The Commission has issued the enclosed Amendments Nos. 108, 108, and 105 for Licenses Nos. DPR-38, DPR-47 and DPR-55 for the Oconee Nuclear Station, Units Nos. 1, 2 and 3. These amendments consist of changes to the Station's common Technical Specifications (TSS) in response to your request dated March 8, 1982.

These amendments revise the TSS to reinstate the heatup and cooldown curves for Unit 1 which had been revised by License Amendments Nos. 107, 107 and 104 which were issued on February 22, 1982.

SAFETY EVALUATION BY THE OFFICE OF NUCLEAR REACTOR REGULATION
SUPPORTING AMENDMENT NO.108 TO FACILITY OPERATING LICENSE NO. DPR-38

OCONEE NUCLEAR STATION, UNITS NOS. 1, 2 AND 3

Figure 3.1.2-1A

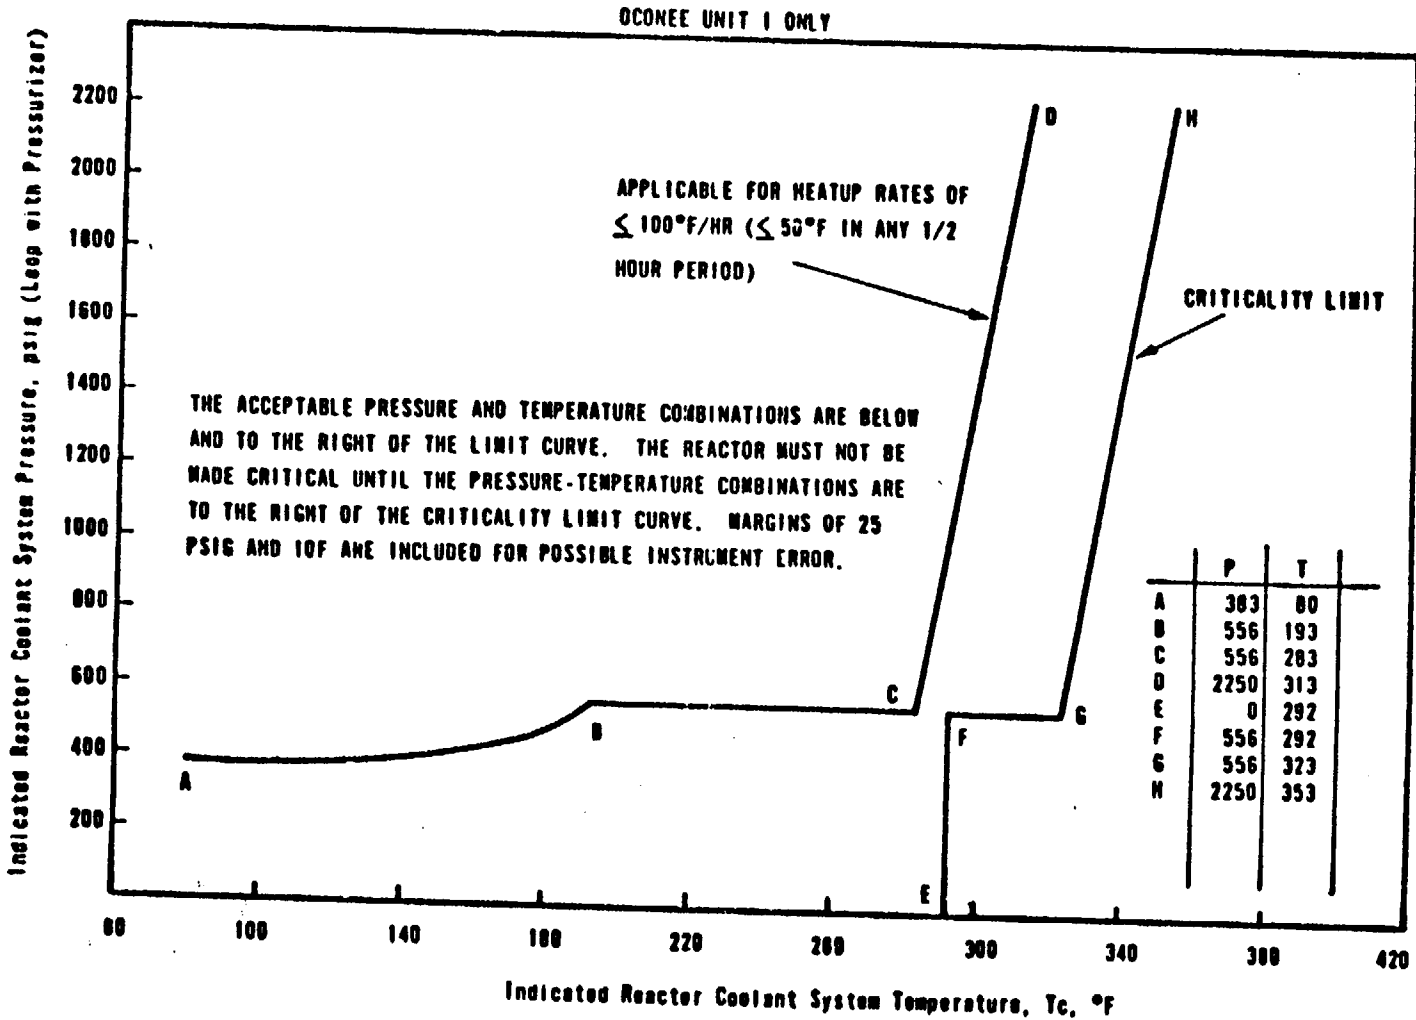
Duke's request to reinstate the heatup and cooldown curves for Oconee Unit 1 has been reviewed and determined to be little more than an administrative change to the TSs. The heatup and cooldown curves for normal operation of Oconee Unit 1 were approved by License Amendments 71, 71 and 68, which were issued on March 19, 1979, to be applicable for the first six effective full power years (EFPY) of operation. Since Oconee Unit 1 has an accumulated service life of approximately 5.1 EFPY, the curves which were superceded by more conservative replacements are still valid and sufficiently conservative for the remainder of the first six EFPY.

REACTOR COOLANT SYSTEM
 NORMAL OPERATION-HEATUP LIMITATIONS APPLICABLE FOR FIRST
 6.0 EFFECTIVE FULL POWER
 YEARS
